# TECHNICAL BULLETIN

[Issue No.] GOT-A-0045-A

[Title] Indication Change with the Revision of the Radio Waves Act (South Korea)

[Relevant Models] GOT1000 Series

1) Indication on the product

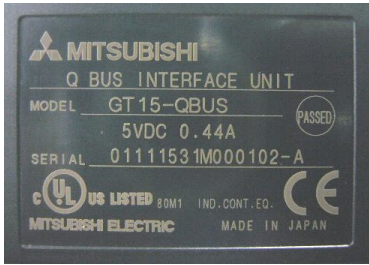
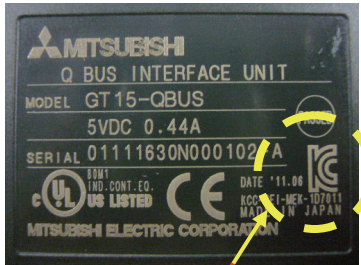
- Models that have conventionally complied with the act  
 The KCC mark is replaced with the KC mark.  
 The indication of a certification number remains the same.  
 The indication of the manufacture year and month (DATE) is added.

Before change	After change
Indication		 <div style="border: 1px solid red; padding: 5px; margin-top: 10px; width: fit-content; margin-left: auto; margin-right: auto;">                 Changes: The mark is changed.                  The manufacture year and month (DATE) is added.             </div>

- Models that newly comply with the act  
 The indications of the KC mark and a certification number are added.  
 If the model is too small to indicate them, only the KC mark is indicated.  
 The indication of the manufacture year and month (DATE) is added.

Before change	After change
Indication		 <div style="border: 1px solid red; padding: 5px; margin-top: 10px; width: fit-content; margin-left: auto; margin-right: auto;">                 Changes: The KC mark is added.                  A certification number is added.                  The manufacture year and month (DATE) is added.             </div>
